Access Compliance Report

Public Rights-of-Way

Intersection ID: 17986	Main Street: E_INDEPENDENCE_BV	Cross Street: DION_AV	Location: NE
ADA ID: 1970F6DF1ADB	Ramp Type: PerpDiag	Initial Pass/Fail: Fail	Overall Compliance: No
			Severity Score: 13.75

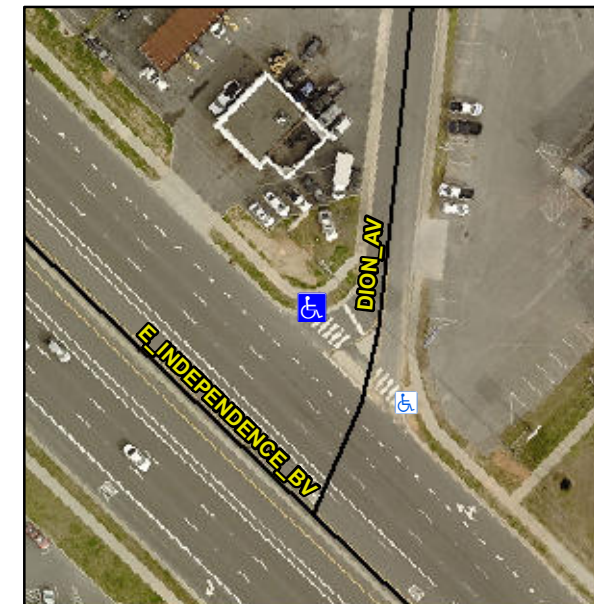
R304.2.2, R304.5.3

Compliance	Description	Data	Compliance	Description	Data
N/A	Ramp Length (in)	66.0	No	Ramp Slope (%)	9.9
Yes	Ramp Width (in)	48.0	No	Ramp XSlope (%)	3.4
N/A	Flare Type LT	N/A	N/A	Flare Type RT	N/A
N/A	Flare Slope LT (%)	N/A	N/A	Flare Slope RT (%)	N/A
N/A	Flare Traversable LT?	N/A	N/A	Flare Traversable RT?	N/A
N/A	Landing Length (in)	N/A	N/A	DWS Provided?	N/A
N/A	Landing Width (in)	N/A	N/A	DWS Contrast?	N/A
N/A	Landing Slope (%)	N/A	N/A	DWS Length (in)	N/A
N/A	Landing X Slope (%)	N/A	N/A	DWS Full Width?	N/A
N/A	Landing Curb? (Y/N)	N/A	N/A	DWS Offset (in)	N/A
N/A	Shared Landing?	N/A			
N/A	Gutter Ponding?	N/A	N/A	Gutter Slope (%)	N/A
N/A	Gutter Lip Ht (in)	N/A	N/A	Gutter X Slope (%)	N/A
N/A	Painted X Walk1?	No	N/A	Painted X Walk2?	Yes
	X Walk 1 Direction	To SW		X Walk 2 Direction	To SE
N/A	X Walk 1 Width (in)	N/A	N/A	X Walk 2 Width (in)	122.0
	X Walk 1 Slope (%)	2.4		X Walk 2 Slope (%)	1.8
	X Walk 1 X Slope (%)	3.1		X Walk 2 X Slope (%)	0.7

Remove & Replace Curb Ramp With Two New Directional Ramps or Equivalent.
